REMARKS

Dean et al.
Serial No. 09/460,552
Page 14

FIG. 1

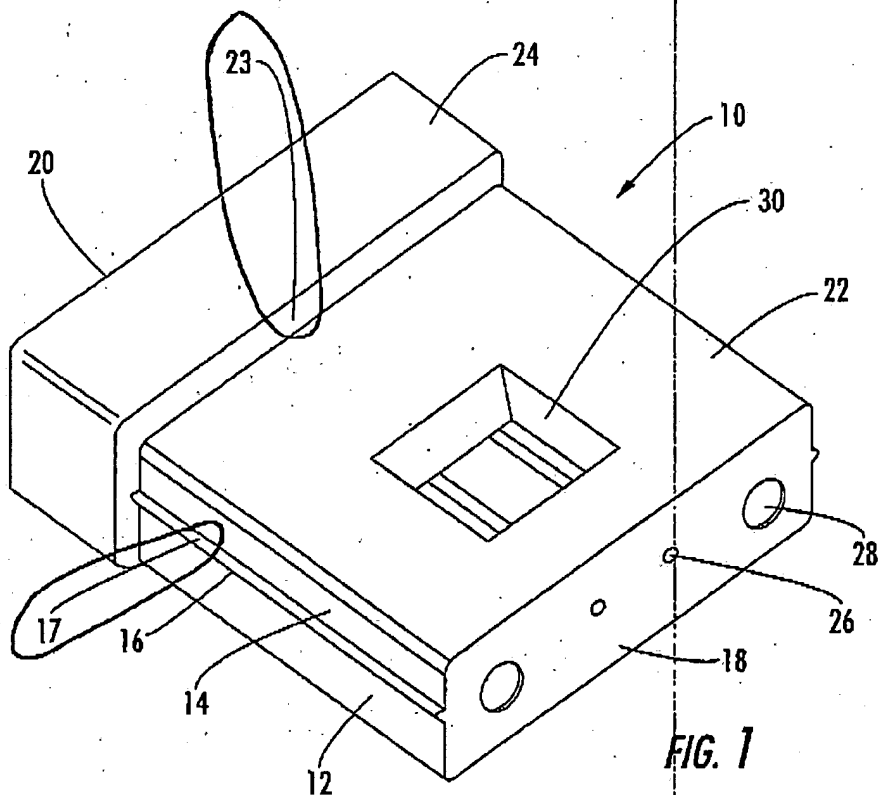
filed beginning at page 2 line 24, and again beginning at page 4, line 30. Attached hereto are proposed changes to FIG. 1 and FIG. 2 of the drawings to add reference numeral identifiers for the ledge 17 and the shoulder 23 in each figure. Replacement drawings comprising Replacement Sheet 1/2 and Replacement Sheet 2/2 are being filed concurrently herewith in full compliance with 37 C.F.R. §§ 1.121(d) and 1.84. Accordingly, Applicants respectfully request the Examiner to withdraw the objection to the disclosure of the specification.

The rear portion 24 and the shaft portion 22 are sized differently such that a shoulder 23 is defined therebetween. The first body portion 12 and the second body portion 14 are also sized differently such that the parting line 16 *comprises a ledge 17 that extends longitudinally (i.e., in the lengthwise direction) over a majority of the length of the ferrule 10 between the front surface 18 and the rear surface 20. As shown, the ledge 17 extends longitudinally between the front surface 18 and the shoulder 23.* (Emphasis added).
